EMBASSY NORTH PRELIMINARY OVERALL AREA DEVELOPMENT PLAN

EMBASSY NORTH
P.O.A.D.P. NAME

Re: Embassy North

File #: 84-16-63-20

SITE PLAN
1"=50'-0"

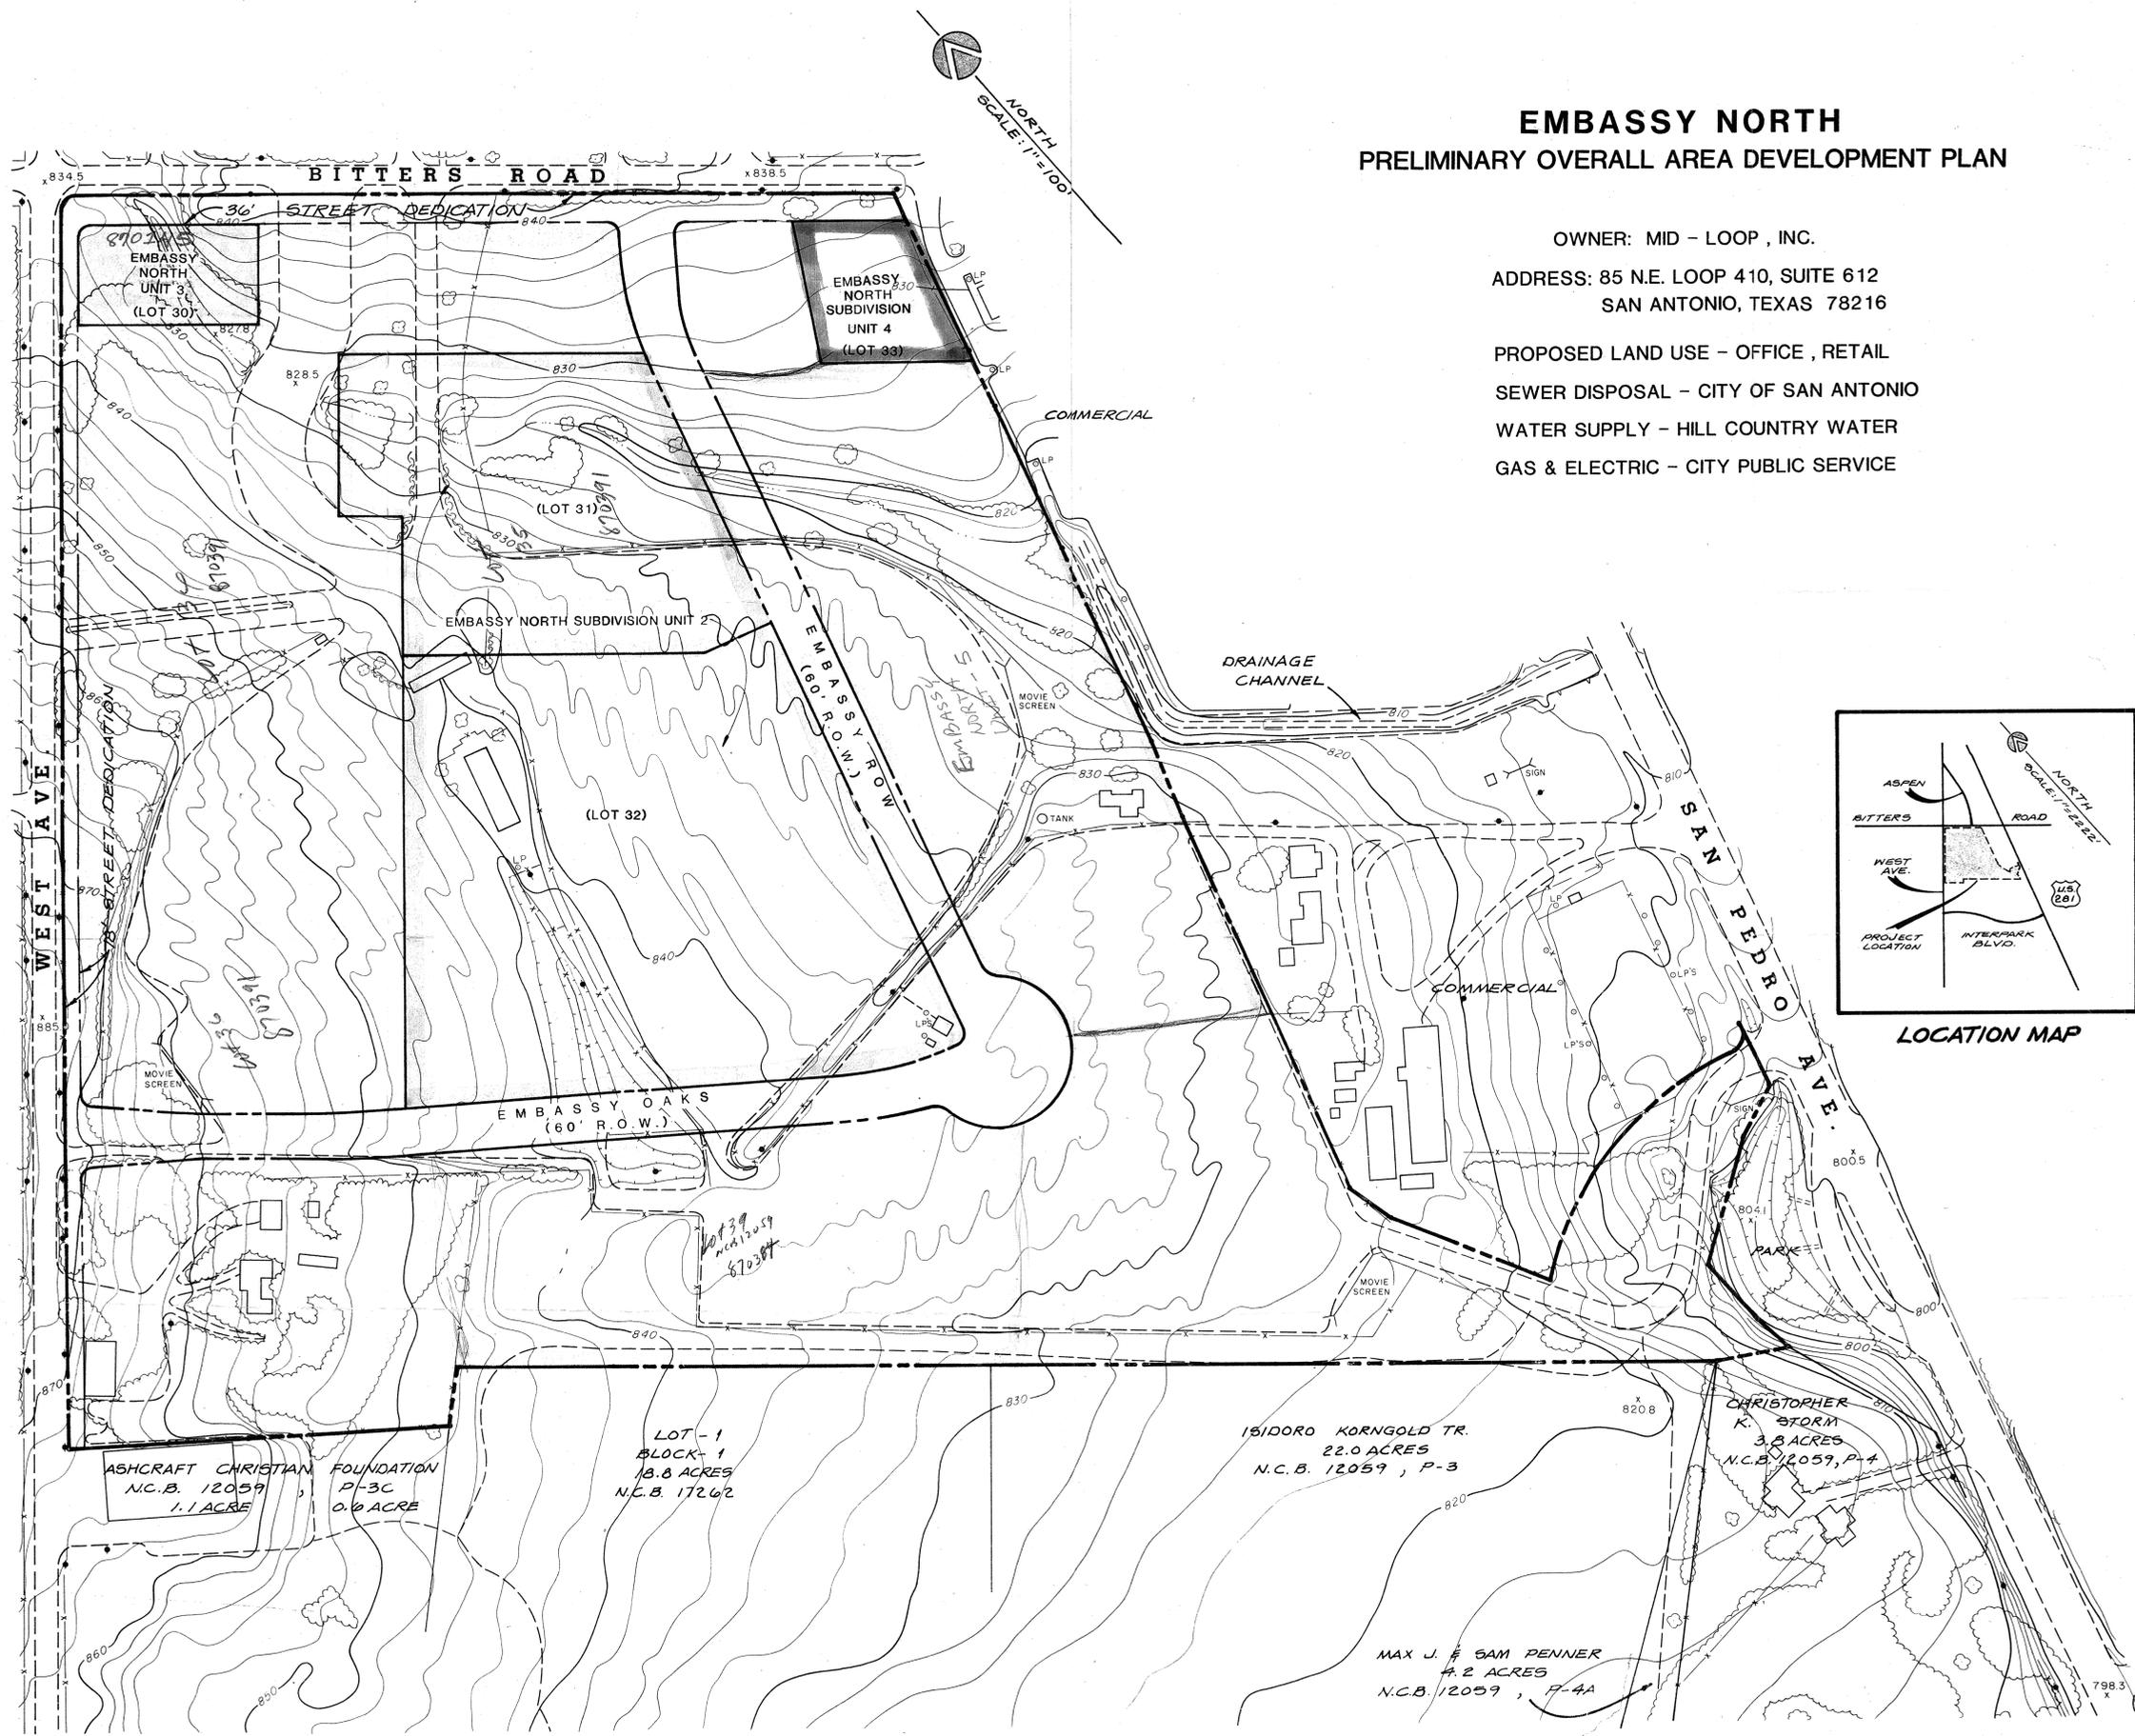
- Street layout
- Relation to adjoining street system
- Stub streets Sec. 36-10(C)
- Street jogs or intersections
- Dead-end streets
- Cul-de-sac streets in excess of 500'
- Lot boundary lines
- Front lot width
- 20' alley(s)

Comments: It will be necessary to provide for a street projection as generally shown on the attached POADP. Said street will cause a viable linkage with Interpark located to the south. In view of the requirement, it is recommended that you contact the adjacent property owner in an effort to coordinate planning efforts.

This is to inform you that on March 8, 1985, the staff review committee approved the POADP for Park Center at Interpark, located directly south of Embassy North. The plan as approved did not include an interconnection with Embassy North; therefore, please disregard our previous comments recommending that the Embassy North POADP include a stub street to the south.

As you suggested, the Engineers for Interpark were contacted. They have indicated that there are no public streets planned for Interpark. Additionally as presently proposed, by the Interpark, buildings will be placed along the property line common to both Embassy North and Interpark.

Therefore, considering the proposed development plans for Interpark, projection of the street to the property line would not be benefical and would not be conducive to development in the area as presently proposed.
